# 1978 - 1979 Corvette: Service Bulletin: Glass Roof Panel Trim Separation

**Subject:** Glass Roof Panel Trim Molding Separation

**Number:** 79-T-7

**Date:** April, 1979

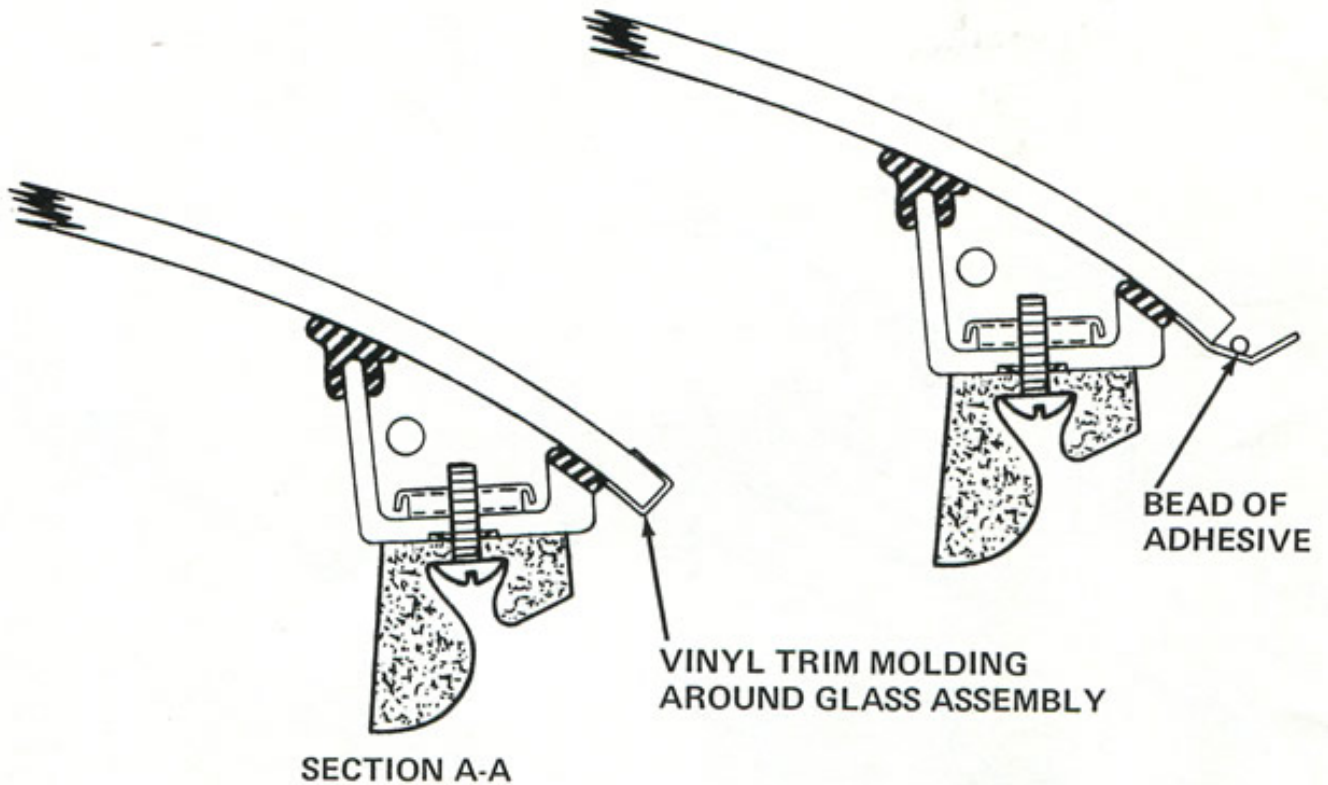
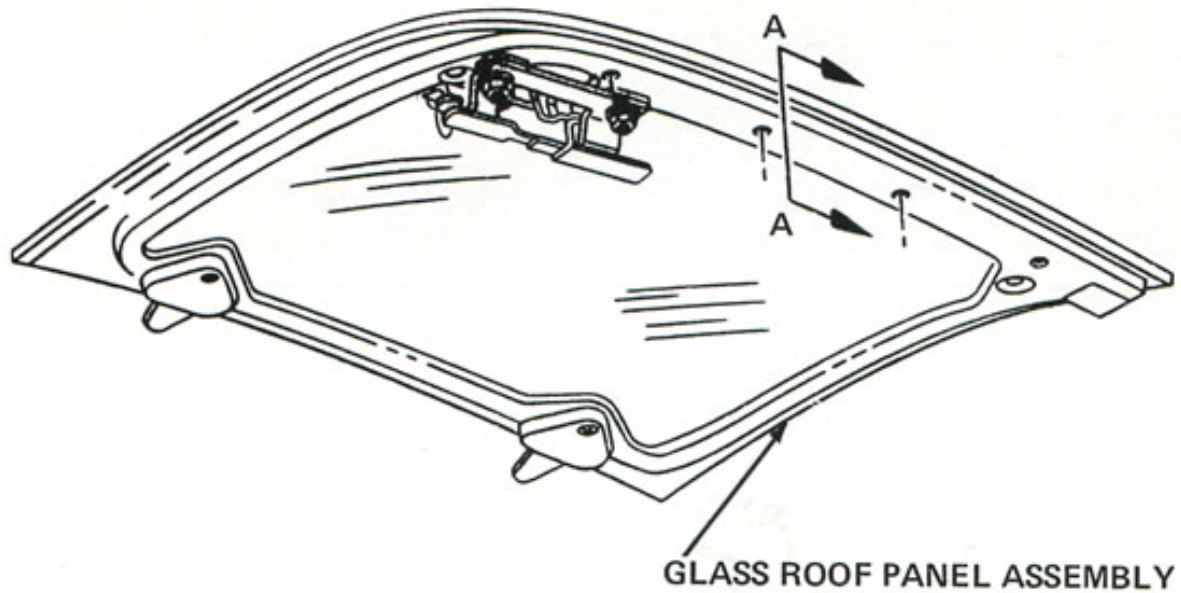
A few 1978-79 Corvettes equipped with the RPO CC1 glass roof panel may exhibit the condition of the vinyl trim molding separating from the glass panel.

The recommended service correction is application of a two part epoxy, such as 3M P/N 8640, or equivalent between the glass panel and the molding.

1. Remove the roof panel from the vehicle, but do not separate the glass from its frame.
2. In the area to be bonded, clean both the molding channel and glass thoroughly with a dry cloth to remove dirt and loose adhesive.
3. Mix epoxy as directed on package. Note cautions and curing time.
4. Transfer the adhesive into a small plastic bag ("baggie") and twist to push the adhesive into a corner. Cut off this corner to provide the proper bead size of approximately 1/16 inch diameter.
5. Apply a 1/16 inch diameter bead of adhesive into the molding channel, as illustrated, and place the channel firmly over the glass edge, allowing the excess adhesive to squeeze out.
6. After the "squeeze out" becomes firm, remove it carefully with a dull blade.
7. Allow approximately one hour cure time at room temperature before

reinstalling the roof panel.
